ISSUE FOR
Rezoning Petition 2014-079

NO.	REASON	DATE
△	PER REVIEW COMMENTS	10.17.14
△	PER REVIEW COMMENTS	11.21.14
△	SITE PLAN AMENDMENT	12.18.17

PROJECT NAME
TRYON PLACE
OFFICE
601 SOUTH TRYON
CHARLOTTE, NC

SHEET TITLE
TECHNICAL DATA SHEET

SHEET NUMBER
RZ-01

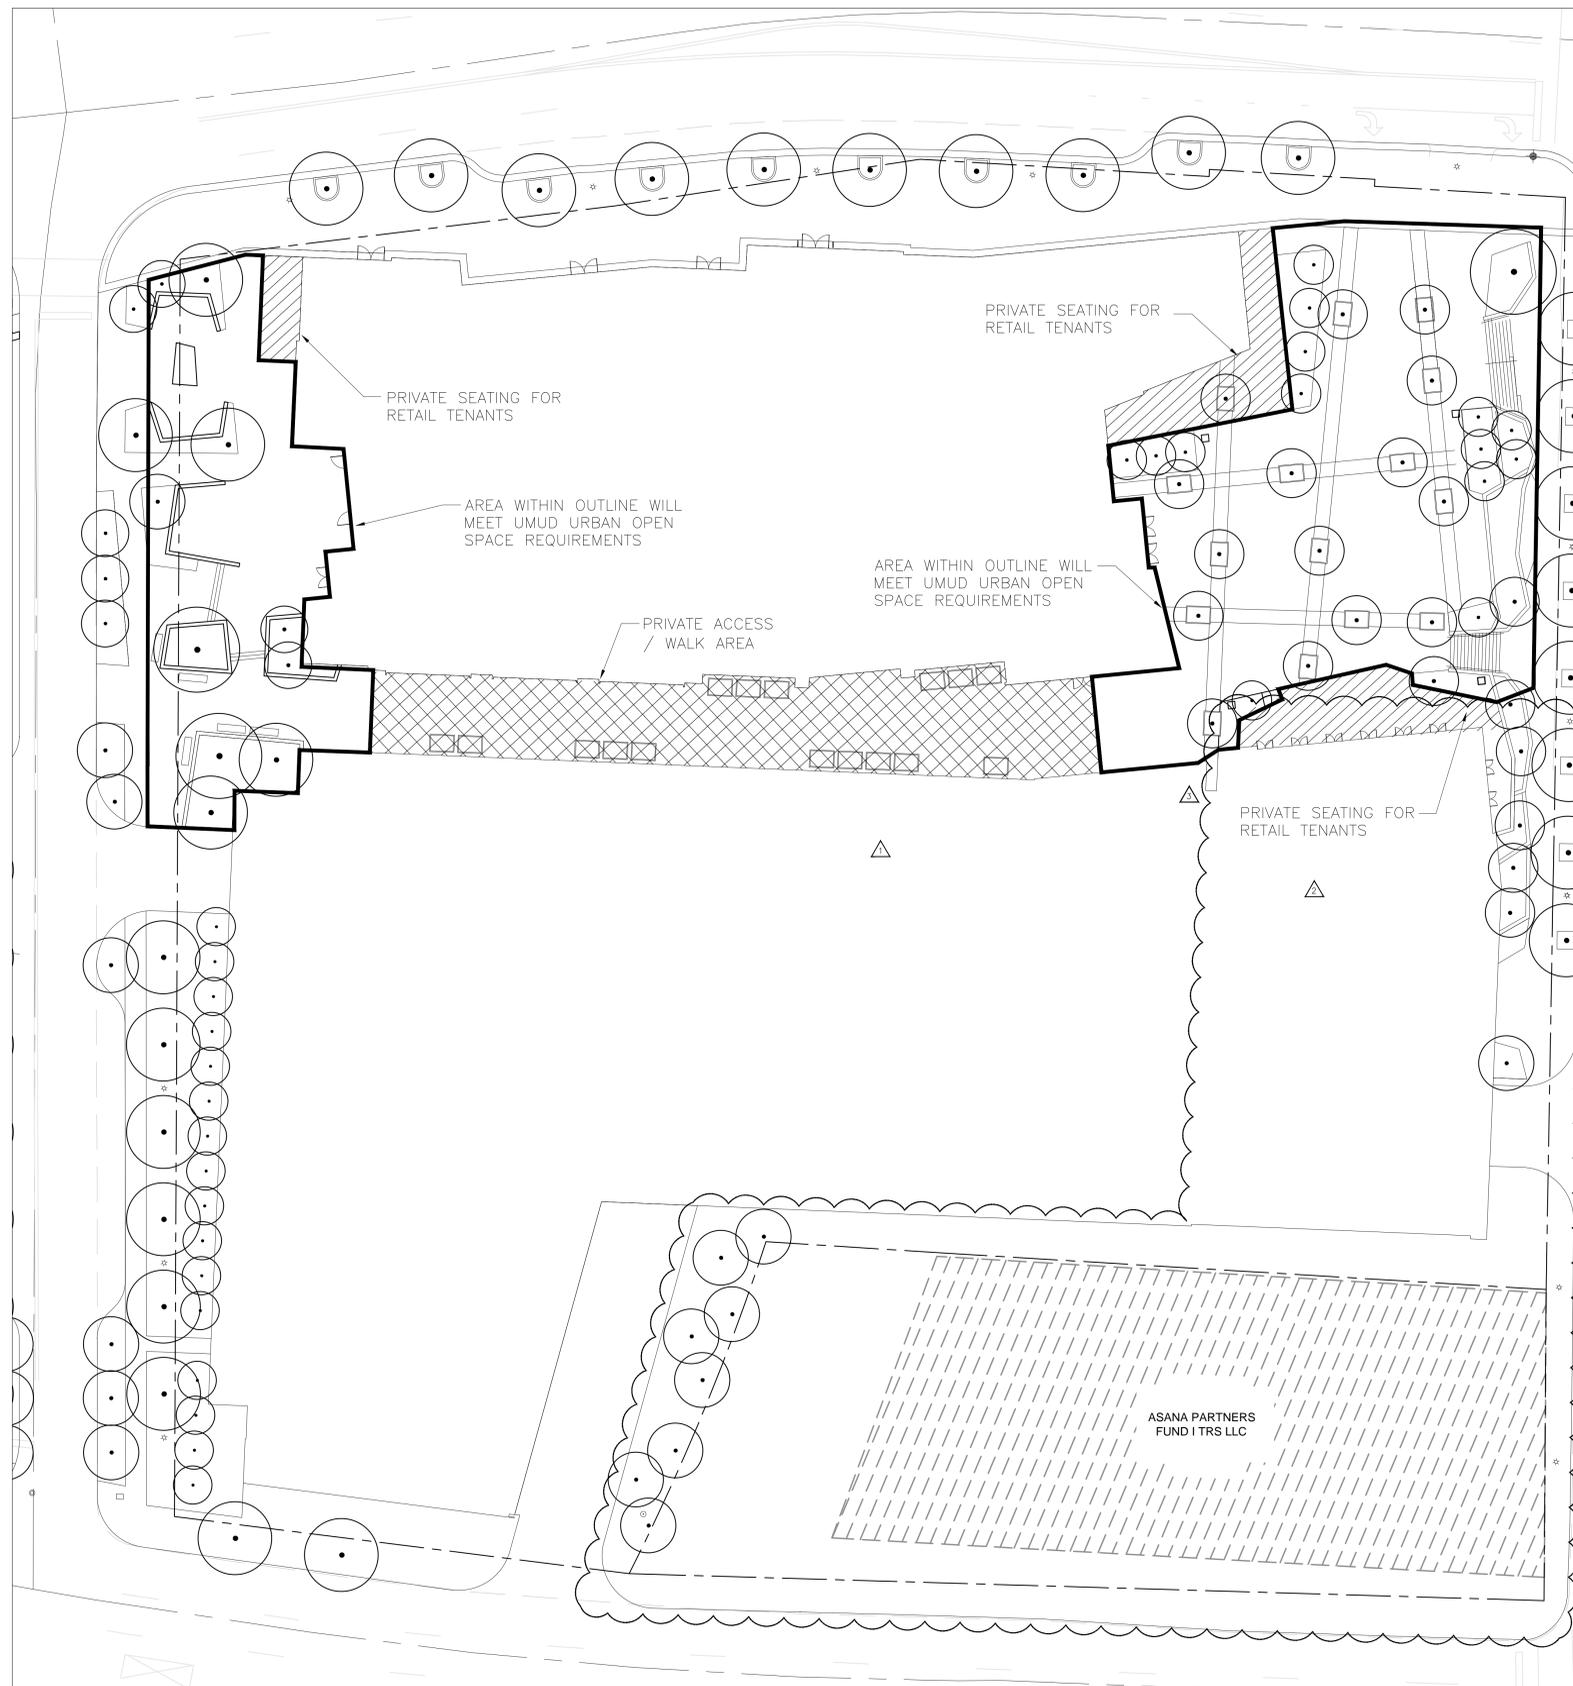
The Development Standards set forth herein are an amendment to the Development Standards submitted and approved in a 2014 Rezoning Plan (Petition No. 2014-079). The purpose of this Site Plan Amendment is to obtain approval of additional "Optional" provisions allowing deviations from certain provisions of the City of Charlotte Zoning Ordinance (the "Ordinance") as allowed by section 9.908 of the Ordinance to provide additional development flexibility which will facilitate the development of a 3.5 +/- acre property bounded by Tryon Street, Stonewall Street, College Street and Hill Street in the City of Charlotte comprised of Mecklenburg County Tax Parcel numbers 125-121-01, 125-121-02, 125-121-03 and 125-121-05 (the "Site"). For the most part, the development standards set forth below are identical to the Development Standards in Rezoning Petition 2014-079. To be clear, provisions of Rezoning Petition 2014-079 are set forth below for ease of recognition. They do not create new entitlements in addition to those in Rezoning Petition 2014-079.

Pursuant to the Optional provisions of Section 9.908 of the Ordinance, the Petitioner seeks approval of the following UMUD Optional provisions to allow deviations from specific provisions of the Ordinance in order to accommodate the development depicted on the Technical Data Sheet:

- (a) Deviations from the signage standards established under Section 9.906(e) of the Ordinance to allow up to two attached electronic signs (video or LED screen) with a maximum size of 300 square feet each. Design and location of these signs shall be reviewed and approved by the Planning Department prior to application for sign permits. This signage shall be limited to building identification, tenant identification, and artistic/civic/cultural displays or messages. Off-premises Signs and Outdoor Advertising Signage shall not be permitted.

- (b) Deviations from the signage standards established under Section 9.906(e) of the Ordinance to allow up to 3,000 square feet of wall signage per street frontage (in addition to any approved electronic signs (video or LED)). Signage shall be located with the sign zones shown on RZ-06 and RZ-07. Design and location of a master sign plan shall be reviewed and approved by the Planning Department prior to application for sign permits. This signage shall be limited to building identification, tenant identification, and artistic/civic/cultural displays or messages. Off-premises Signs and Outdoor Advertising Signage shall not be permitted.

- (c) Deviations from the street right-of-way and streetscape requirements established under 9.906(12)(f) of the Ordinance in order to accommodate temporary retail vendor zones, within the right-of-way or setback, subject to the approval of any necessary Encroachment Agreements. The temporary retail vendor zones shall be allowed only in the location specified on the Technical Data Sheet. Any vendors within the retail vendor zone must comply with any applicable street vendor ordinances or policies.

- (e) Deviations from the street right-of-way and streetscape requirements established under Section 9.906(12)(f) of the Ordinance to remove the requirement to provide furniture or benches within the right-of-way along the Site's Tryon Street frontage.

- (f) Deviations from setback requirements established under Section 9.905(2) of the Ordinance, and any applicable streetscape plans in order to allow a reduced setback of fourteen (14) feet measured from the back of curb along Stonewall Street. Portions of the Site's frontages on S. College Street, E. Hill Street and S. Tryon Street must comply with standard Ordinance provisions. Structures within the reduced setback area shall be limited to retaining walls and other features necessary to accommodate the publicly accessible plaza on-grade with Tryon Street, no buildings shall be permitted in the reduced setback area. Walls within the reduced setback area shall incorporate plantings, integrated seating, or other features to stimulate pedestrian interest; all as generally depicted on RZ-03, RZ-04, RZ-05 and RZ-09. Additionally, such walls shall be made of decorative architectural precast or stone or other natural materials, or a combination thereof.

- (g) Deviations from the urban open space seating and tree requirements established under Sections 9.906(4)(d) and (e) of the Ordinance to remove prescribed seating and tree requirements within any non-required, non-public open spaces areas. Standard seating and tree requirements shall be met within portions of the urban open space areas required to meet the minimum UMUD urban open space requirement. Areas not subject to seating and tree requirements are generally identified on RZ-02.

- (h) Deviations from the loading standards established under Section 9.907(2)(c) of the Ordinance to allow a 50% reduction in the number required of loading spaces.

- (i) To allow for a ten (10) foot overhead encroachment into the twenty-two (22) foot streetscape area along Stonewall Street, as recommended by the Center City Transportation Plan, in order to accommodate a cantilevered building design starting at a minimum of twenty-one (21) feet above the sidewalk. To be clear, this encroachment area shall not be permitted at the building's base level.
